CITY OF ALBUQUERQUE

Re: GGP Sertiage JV Redevelopment
600 Menaul Bld NE, Suite 5000 BP#201691798
60-Day Temporary Certificate of Occupancy- Transportation Development
Architect's Stamp dated 07-25-16 (H18D005F)
Certification dated 06-15-17

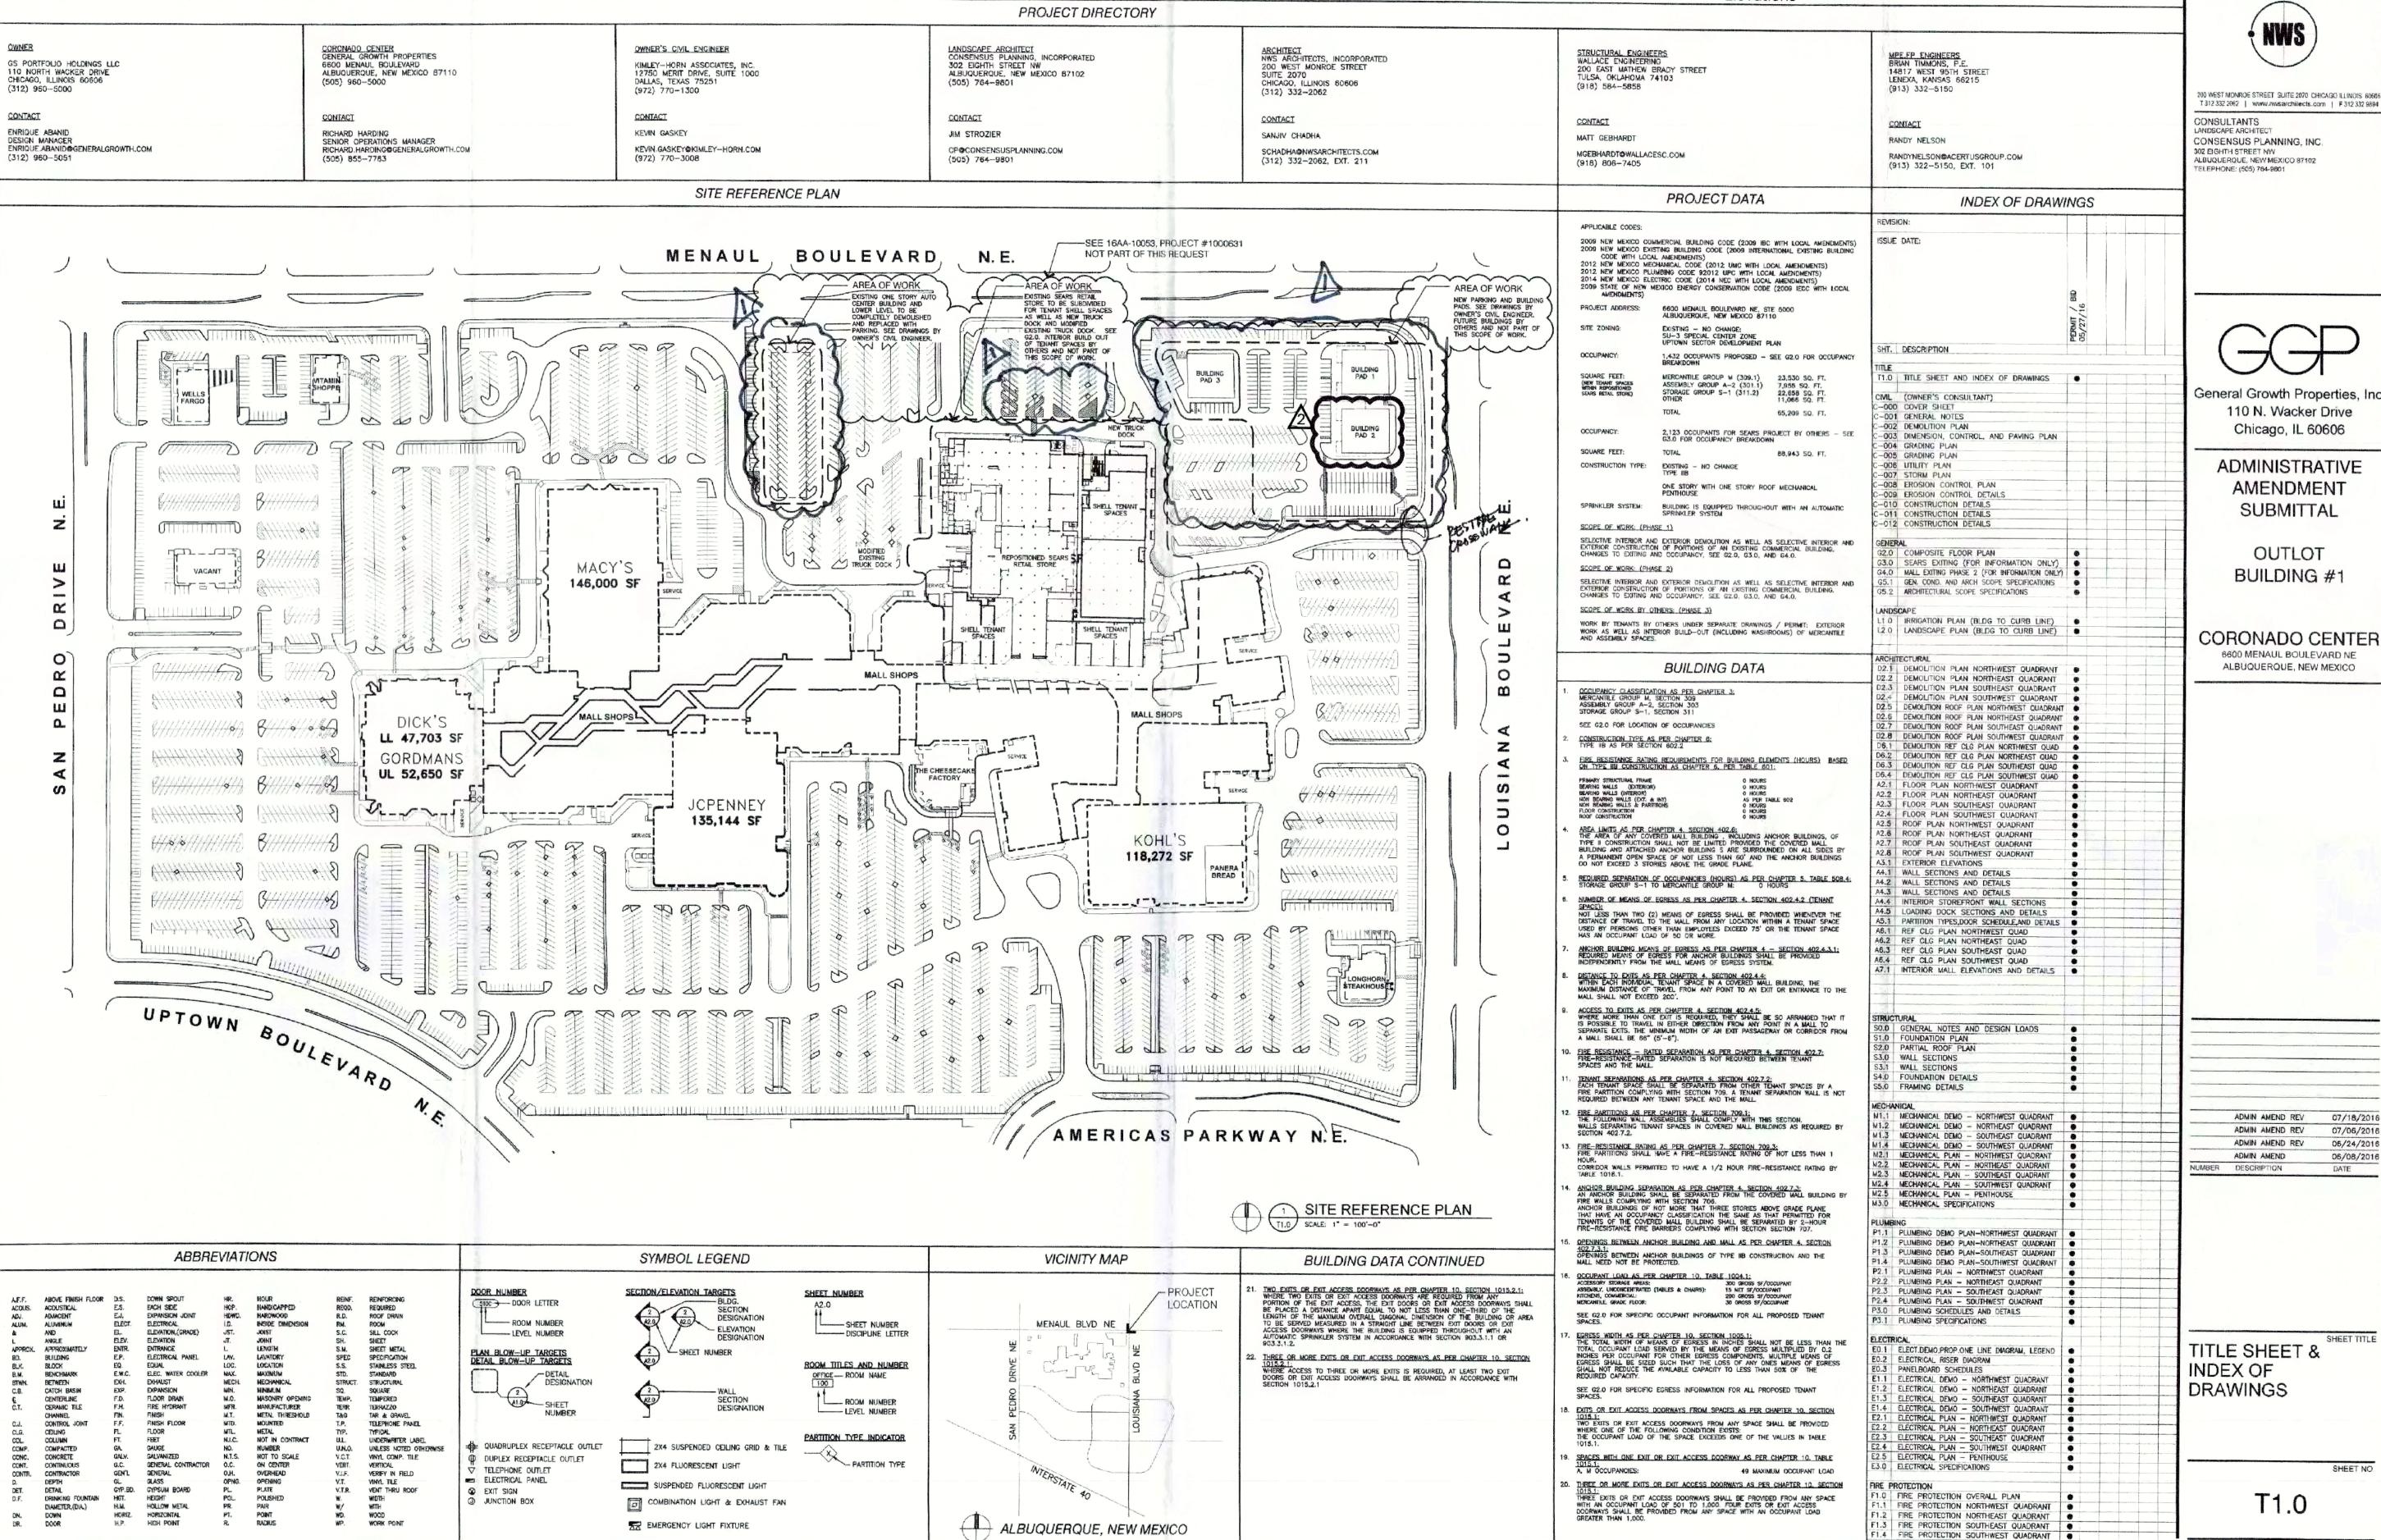
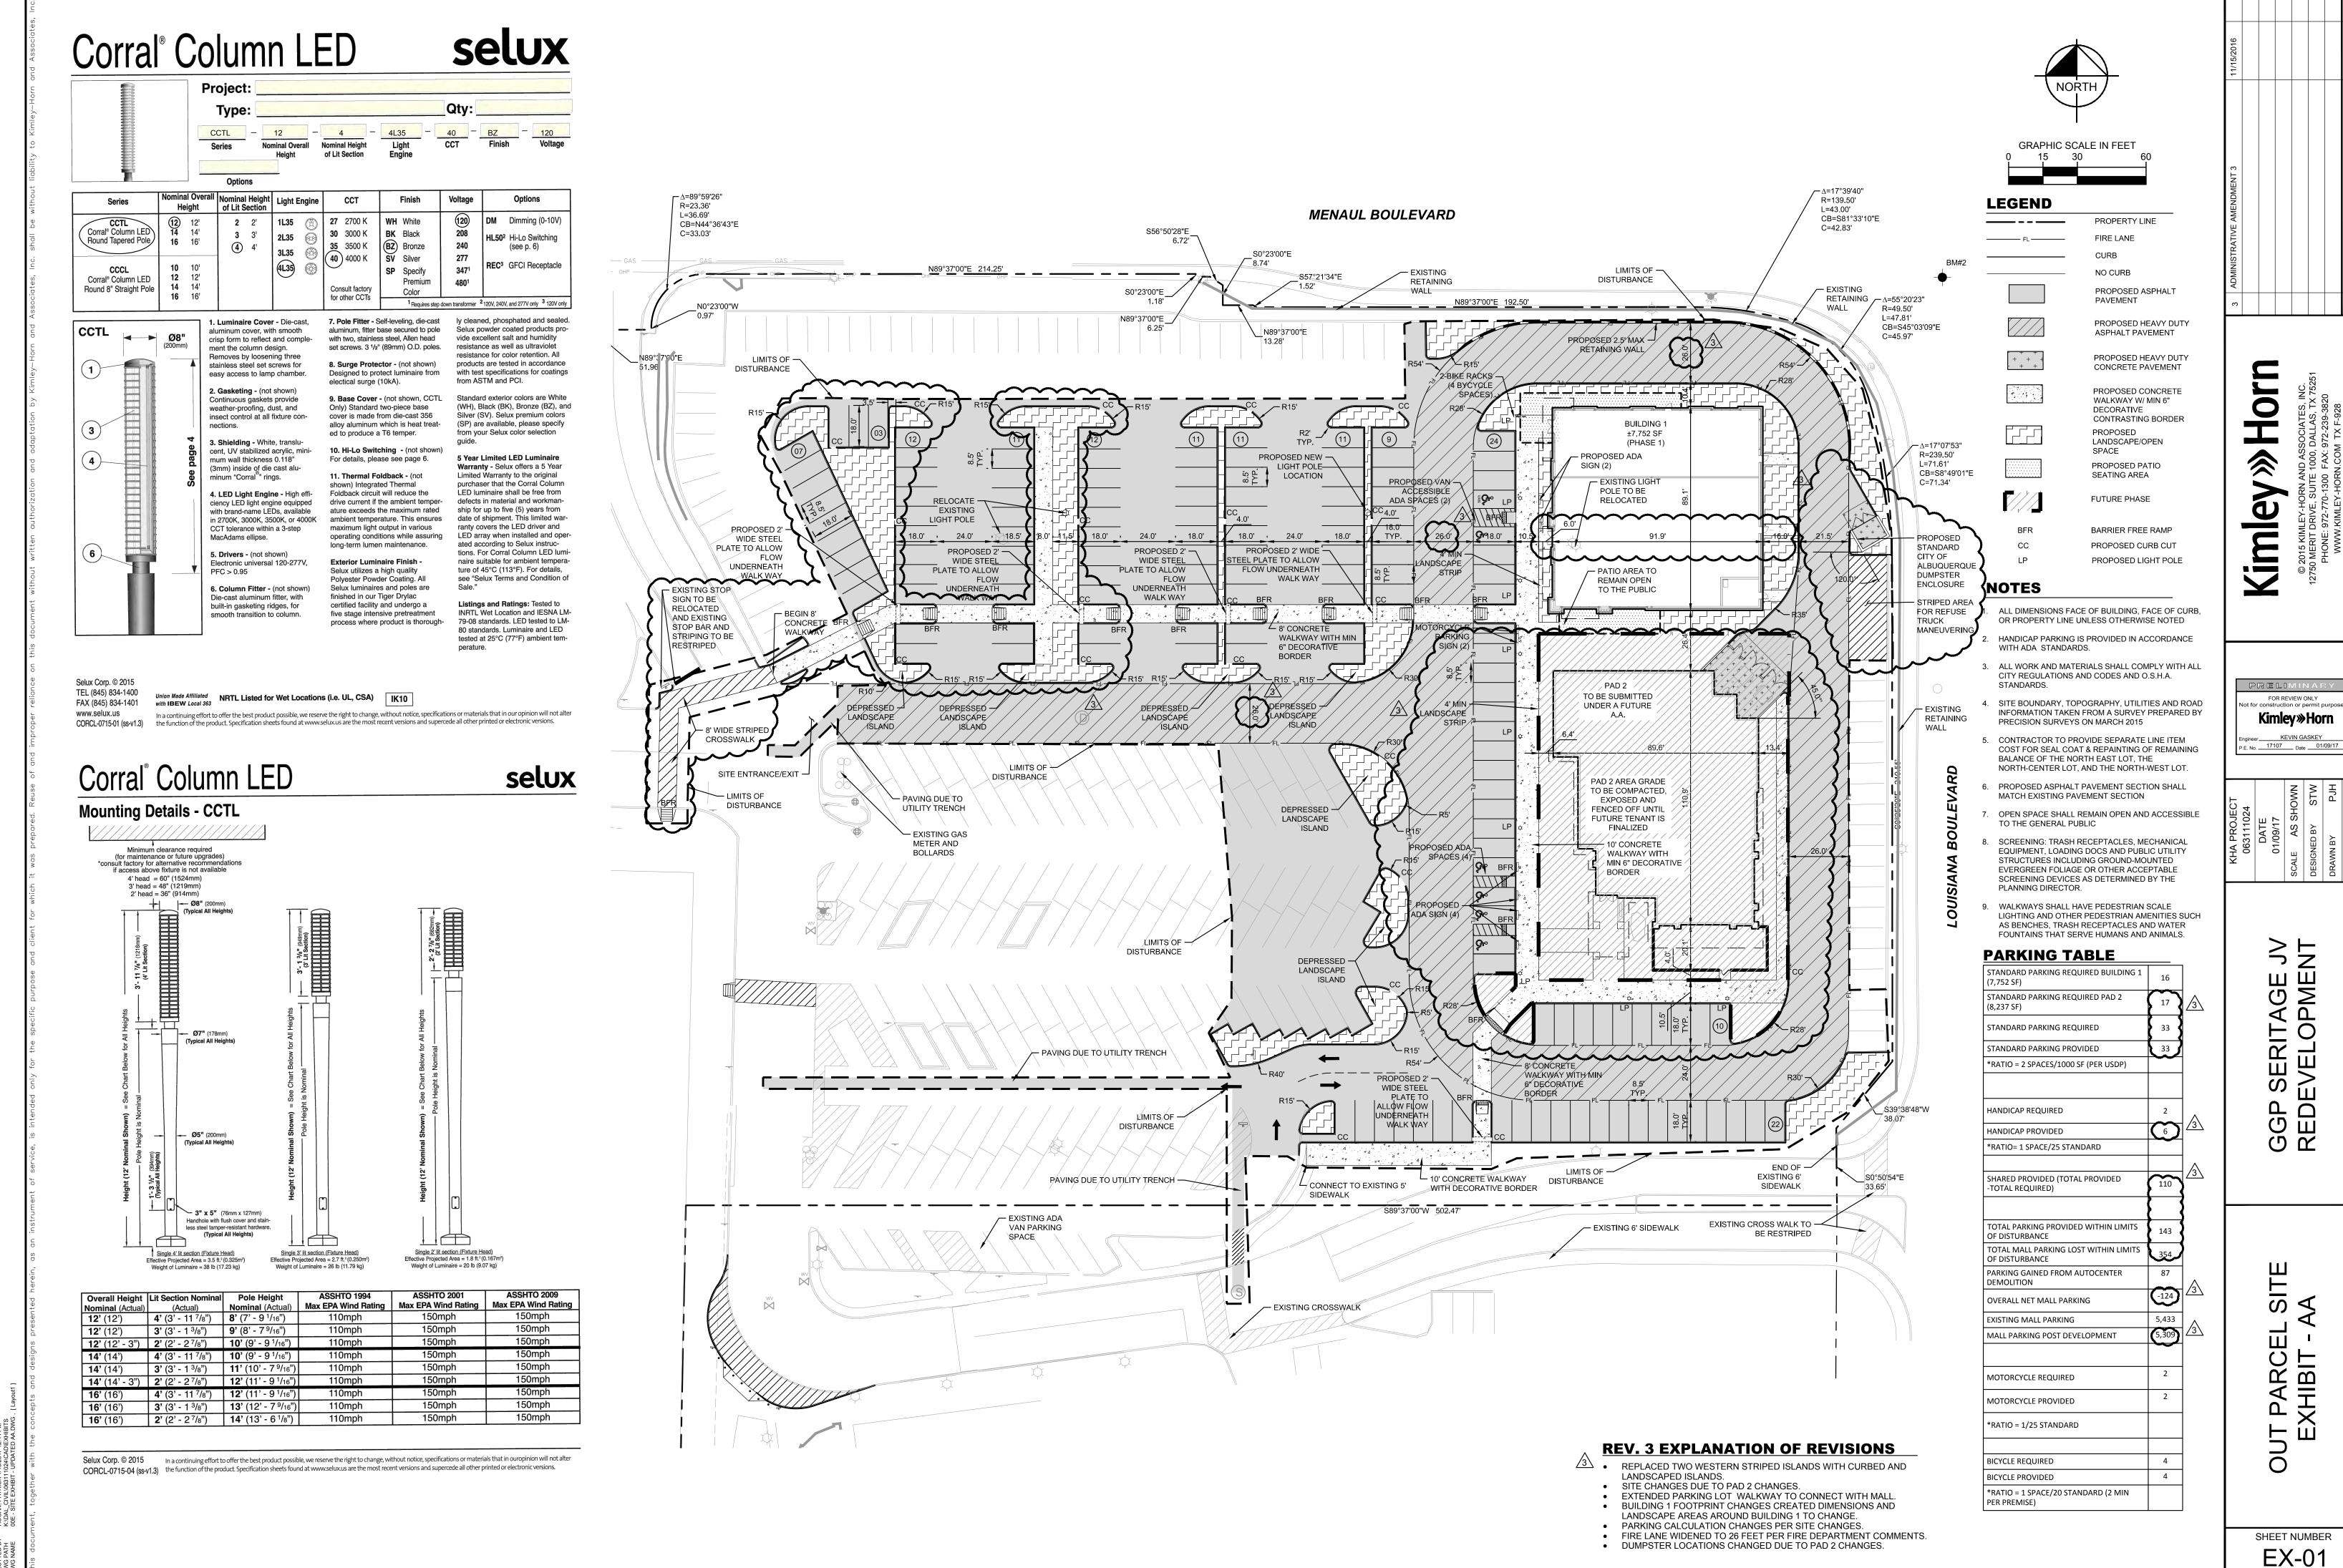
- "NO PARKING" along the fire lane East of the building and South of the dumpster needs to be painted.
- 2. Paint parking spaces missing striping in parking lot see the attached photo.

- 3. The wheelchair ramp located in front of the building must not protrude into the ADA access aisle. See the attached exhibit for requirements of ADA ramps.
- A convex mirror must be added at the location shown on the exhibit attached to the email.
